CITY OF ALBUQUERQUE

RE: Harwood Escuela Phase I
1114 7th Street NW
Grading and Drainage Plan
Engineer's Stamp Date: 12/20/19
Hydrology File: J14D136

GRADING & DRAINAGE PLAN

C101

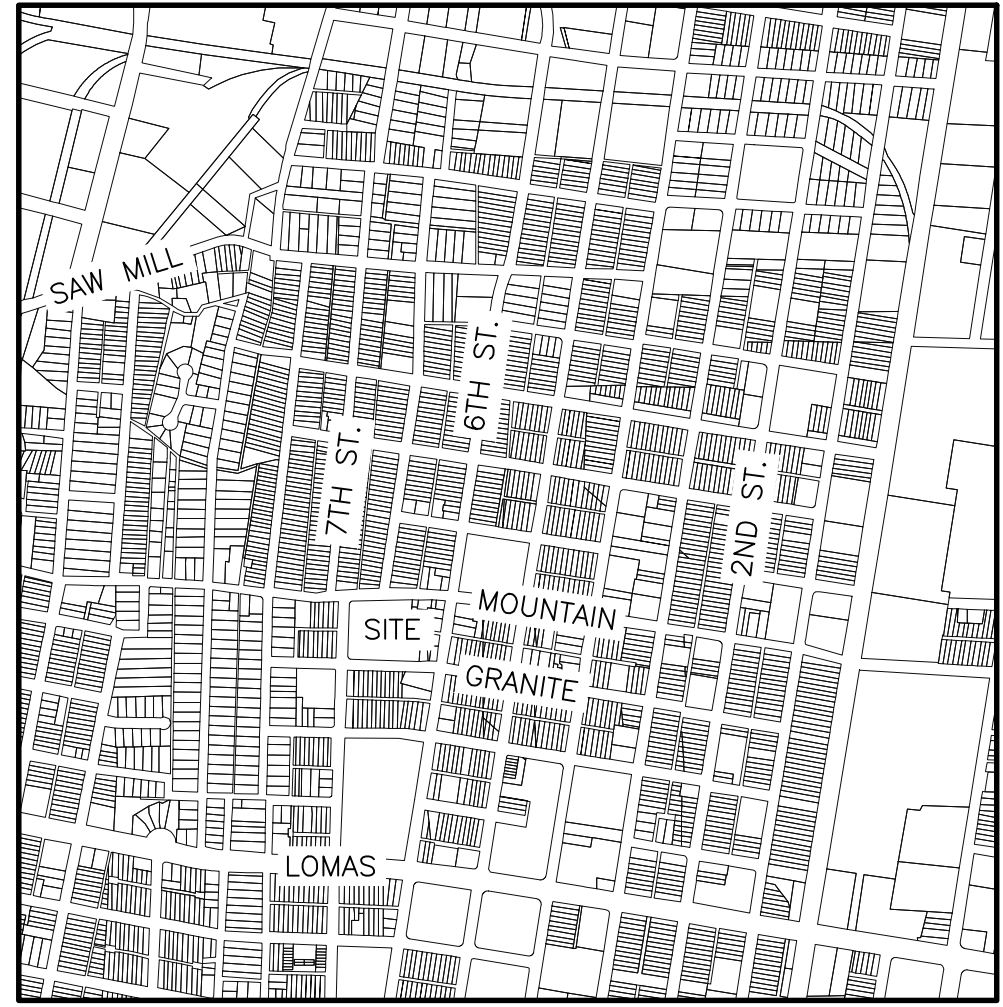
Based upon the information provided in your submittal received 12/19/2019, the Grading & Drainage Plan is approved for Building Permit and Grading Permit.

Please attach a copy of this approved plan in the construction sets for Building Permit processing along with a copy of this letter. Prior to approval in support of Permanent Release of Occupancy by Hydrology, Engineer Certification per the DPM checklist will be required.

As a reminder, if the project total area of disturbance (including the staging area and any work within the adjacent Right-of-Way) is 1 acre or more, then an Erosion and Sediment Control (ESC) Plan and Owner's certified Notice of Intent (NOI) is required to be submitted to the Stormwater Quality Engineer (Dough Hughes, PE, jhughes@cabq.gov, 924-3420) 14 days prior to any earth disturbance.

Also as a reminder, please provide a Drainage Covenant for the proposed underground stormwater quality facility per Chapter 17 of the DPM prior to Permanent Release of Occupancy. Please submit this on the 4th floor of Plaza de Sol. A \$25 fee will be required.
